**Date: March 9, 2023**

**ADDENDUM # 1**

**St. Cloud HRA  
Westwood Village Apartments I & II  
Roof Replacement**

**A2.3**

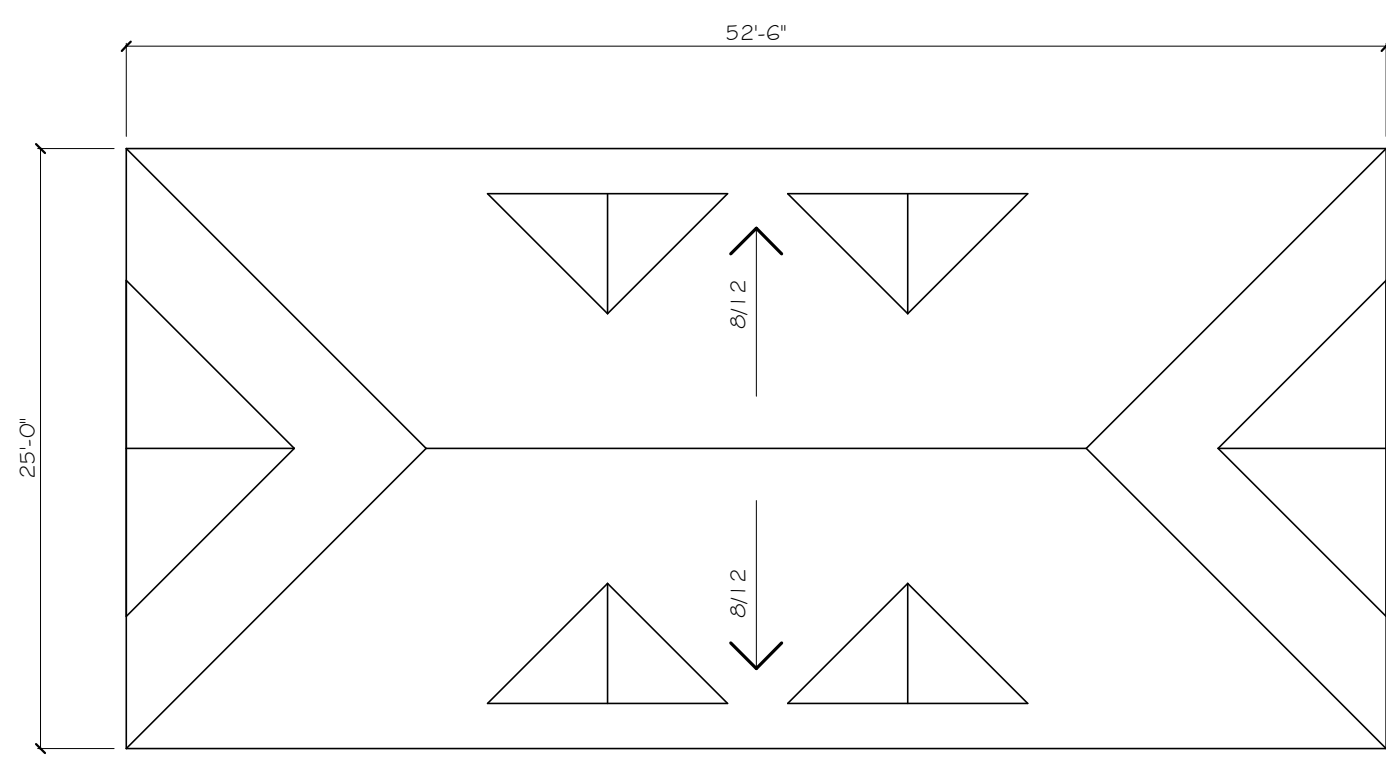
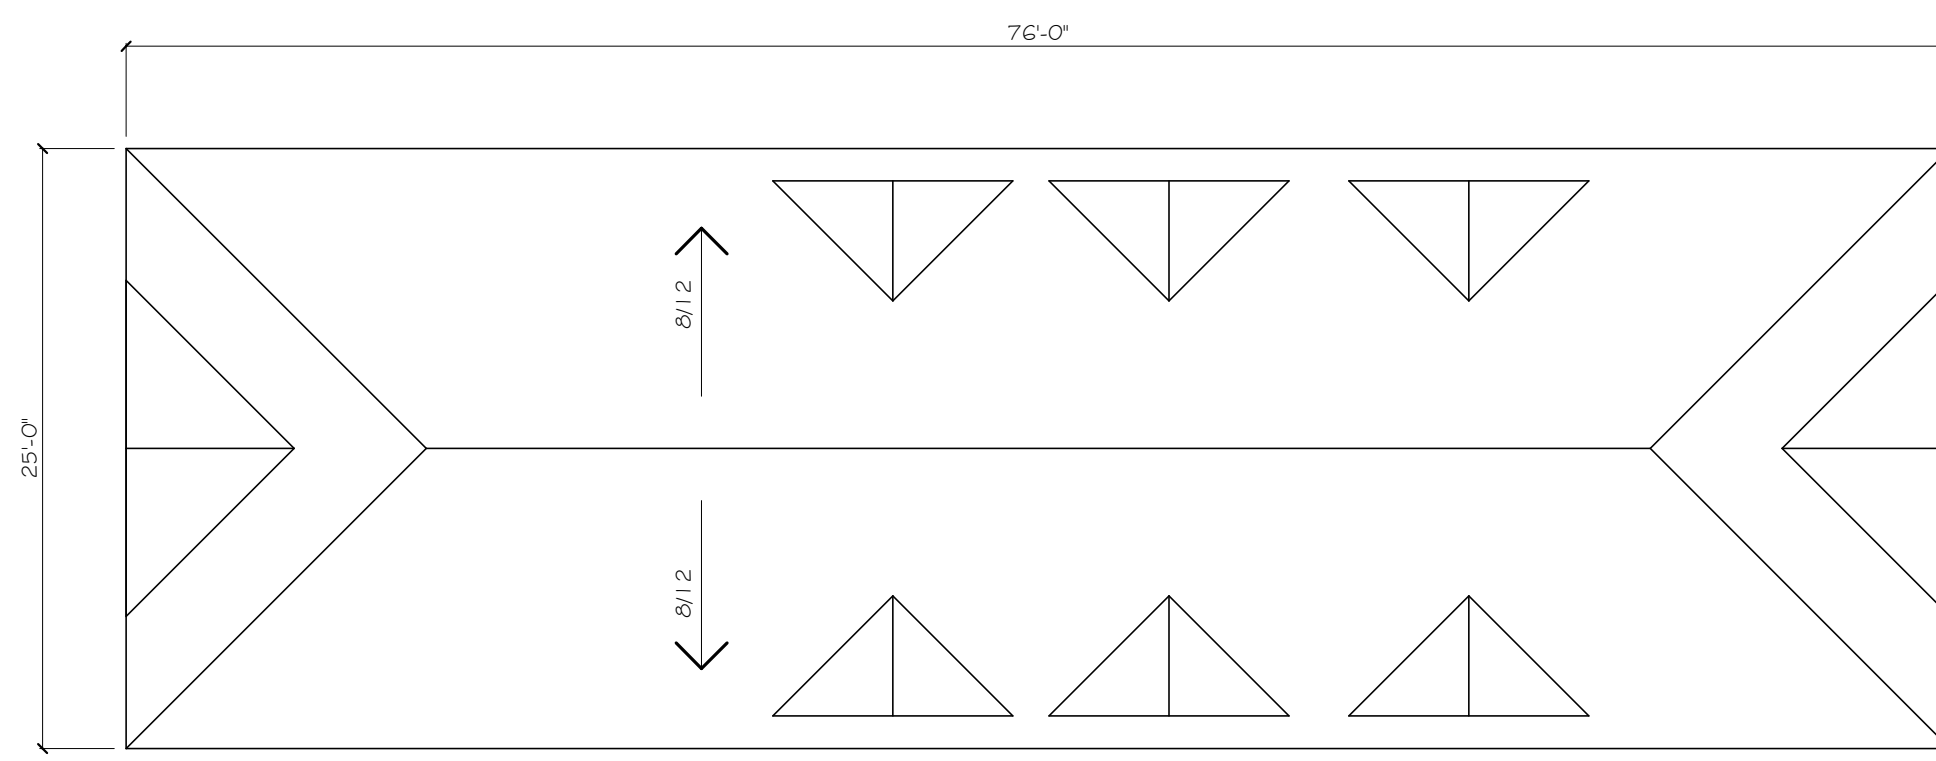
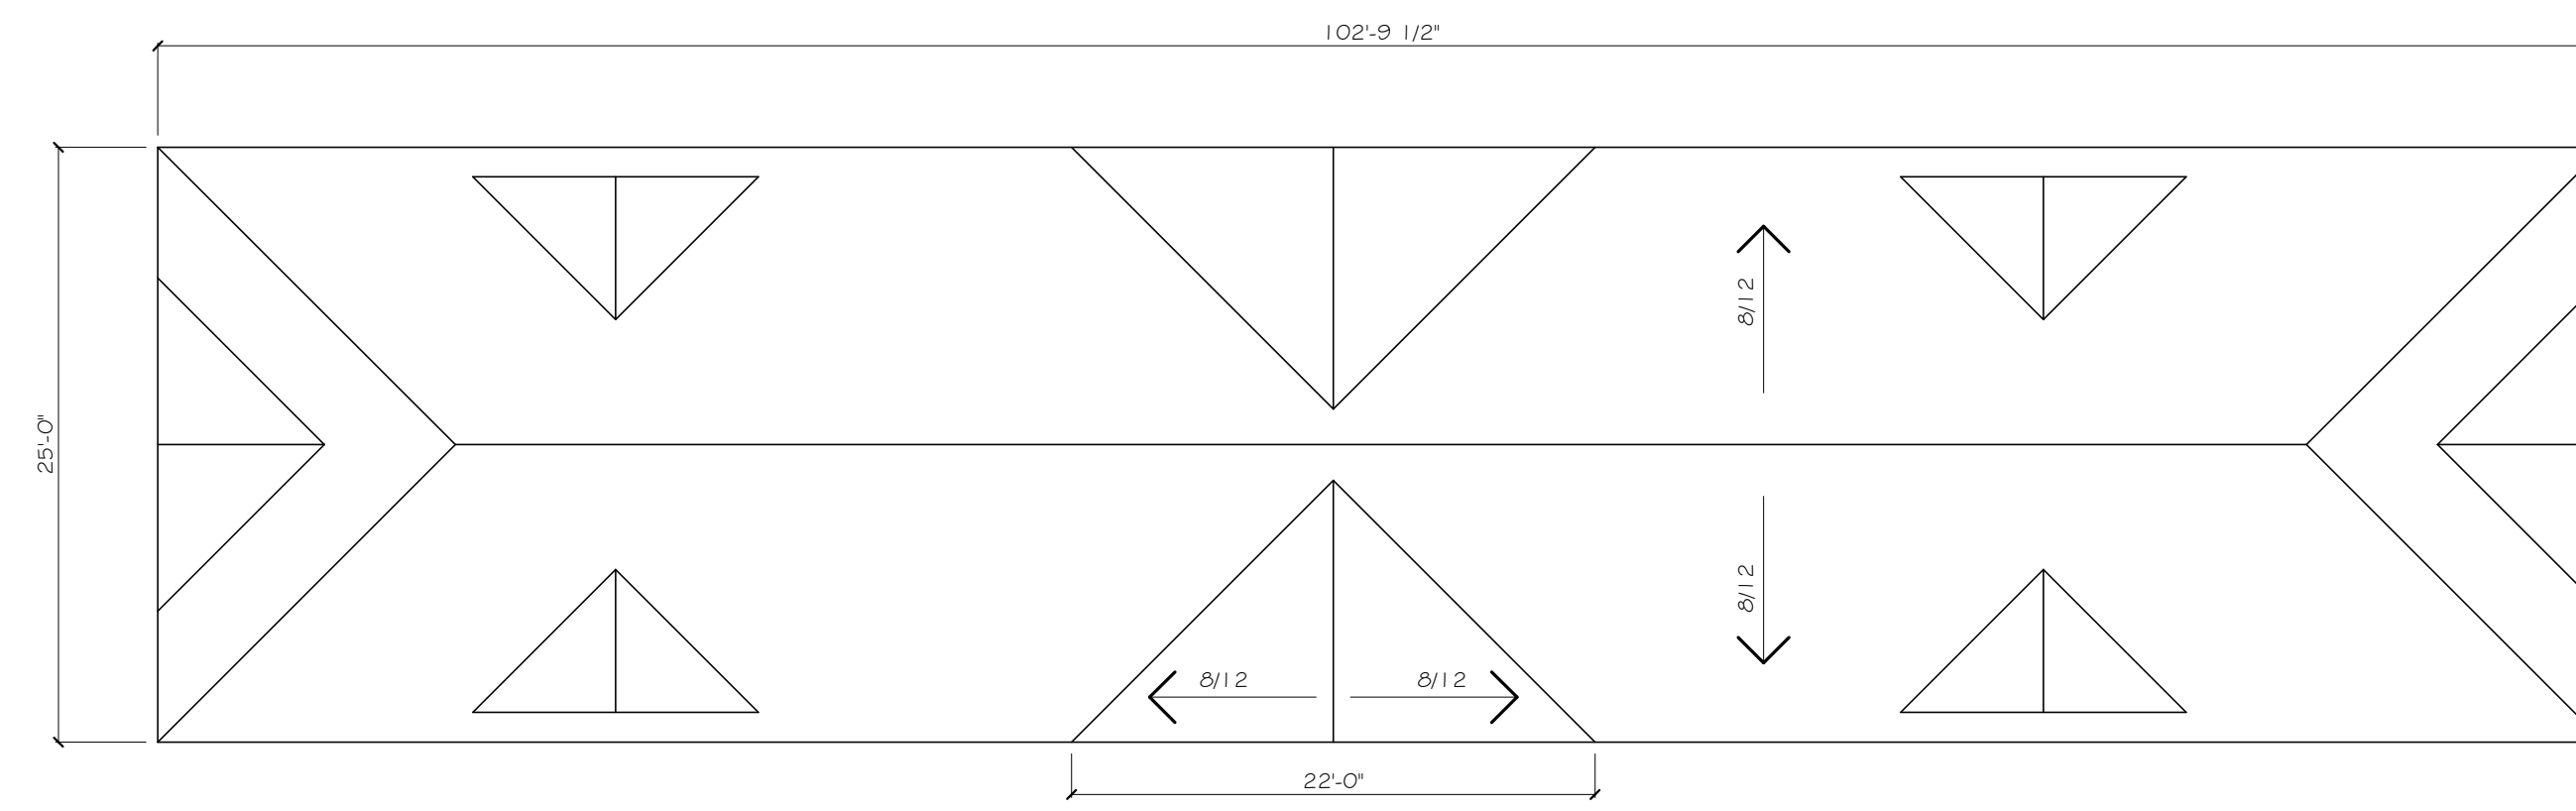
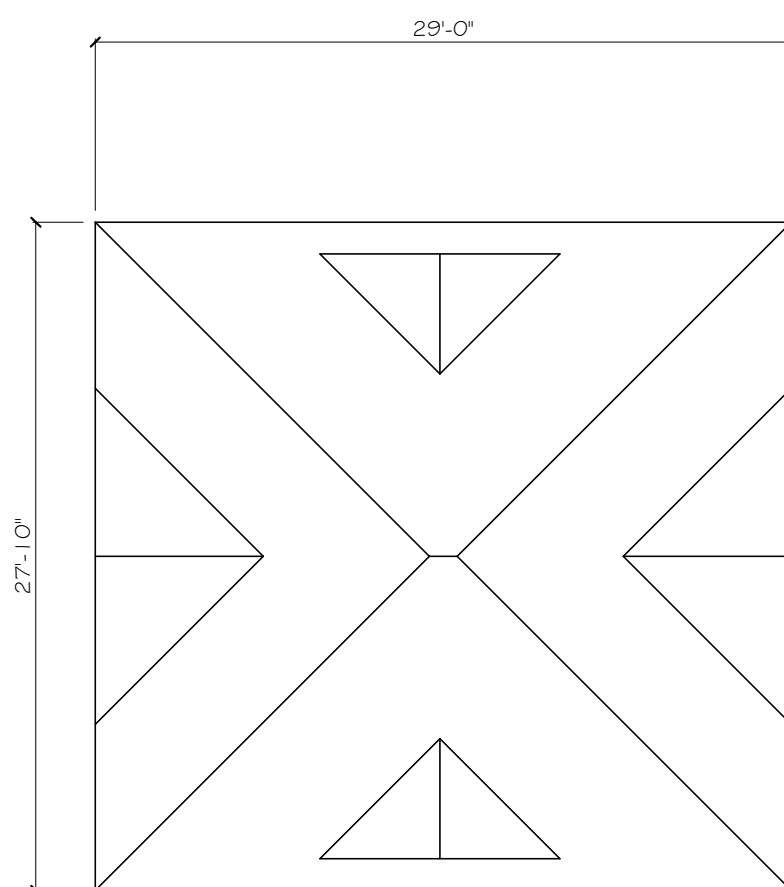
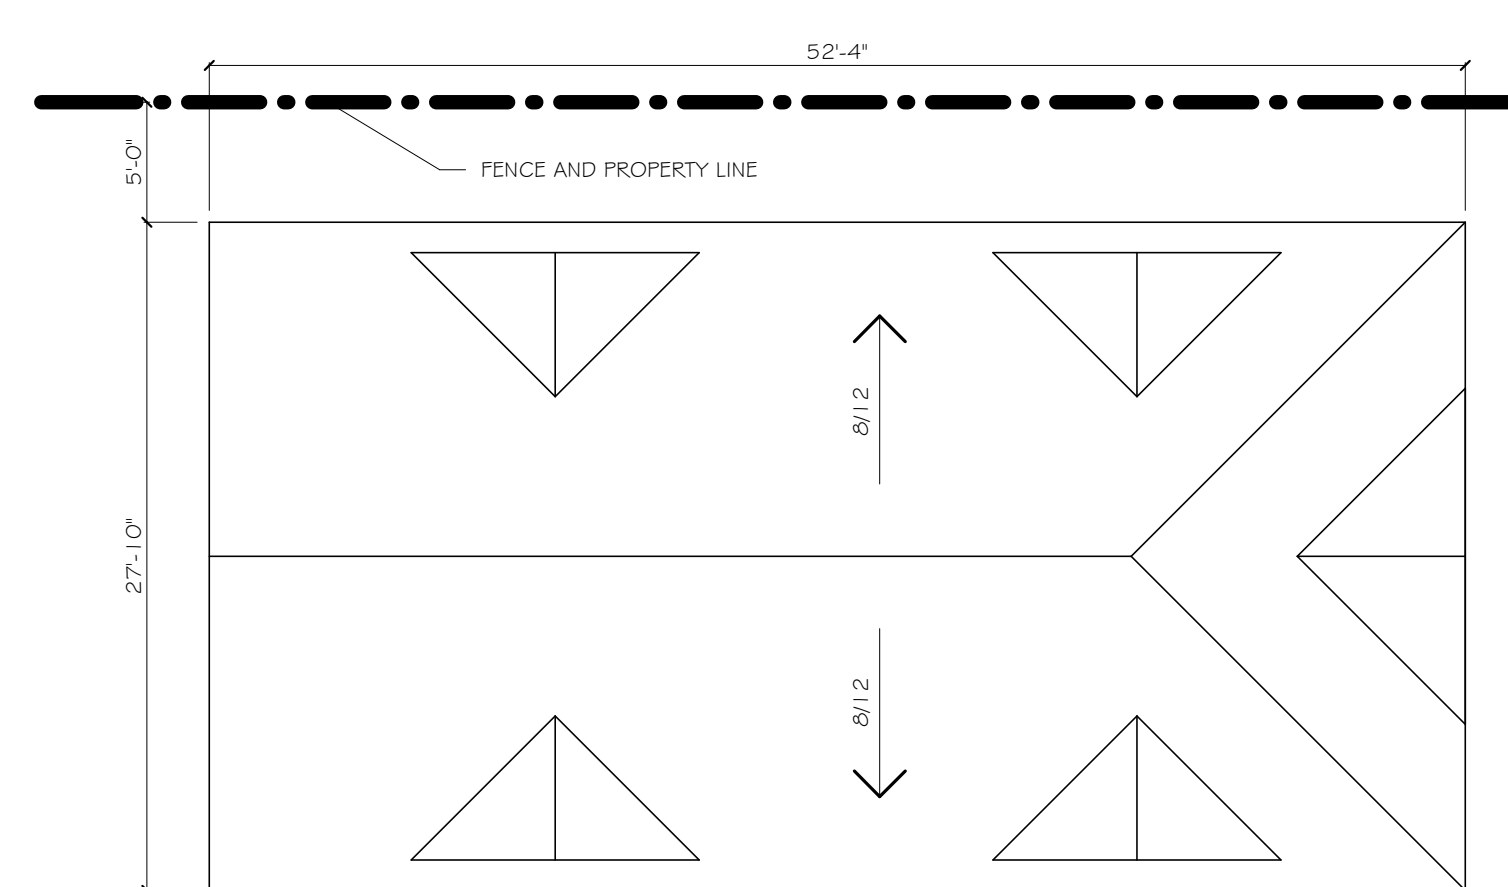
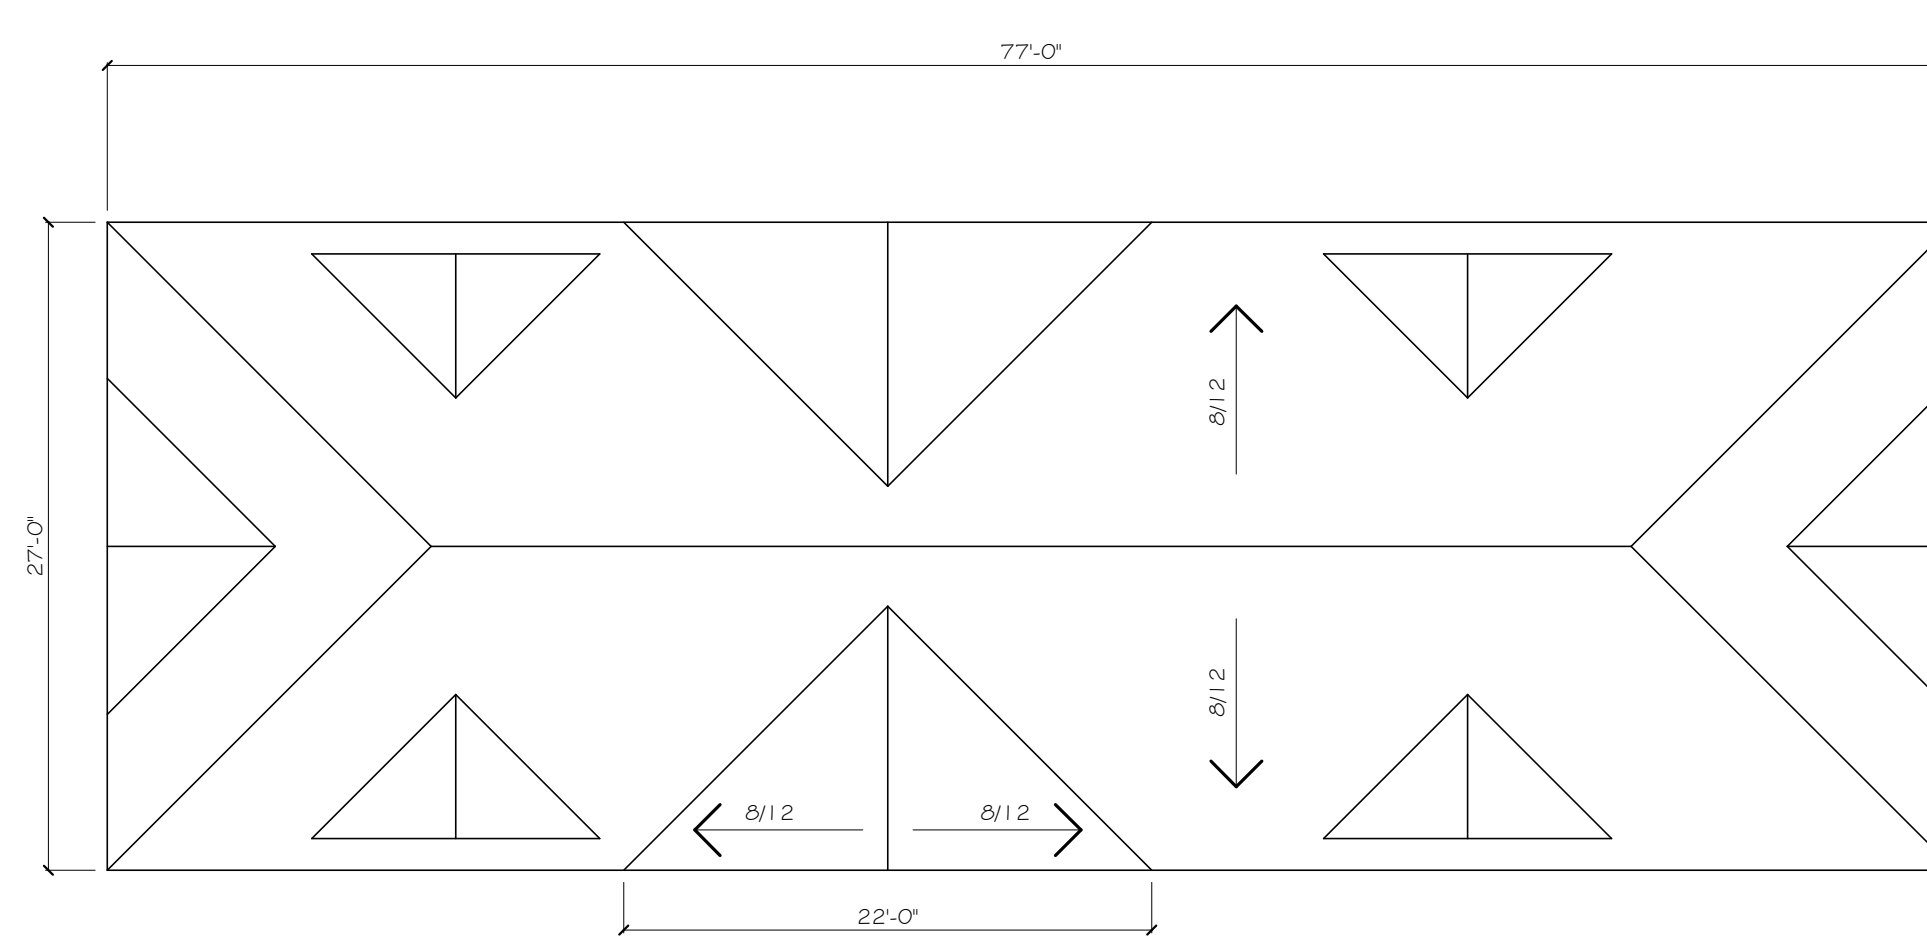
- A.** Add the re-roof of 2 building signs. See photo on Sheet A2.3. Also include signs in alternate 1.
- B.** Added to the notes is the removal and reinstall of the antennas. Owner will re-calibrate antennas.
- C.** The garages are not heated. They will not require ice and water shield.

- TWO BUILDING SIGNS**
- A. REMOVE AND REPLACE SHINGLES ON TWO EXISTING SIGNS, APPROXIMATELY 3'-0" x 6'-0".
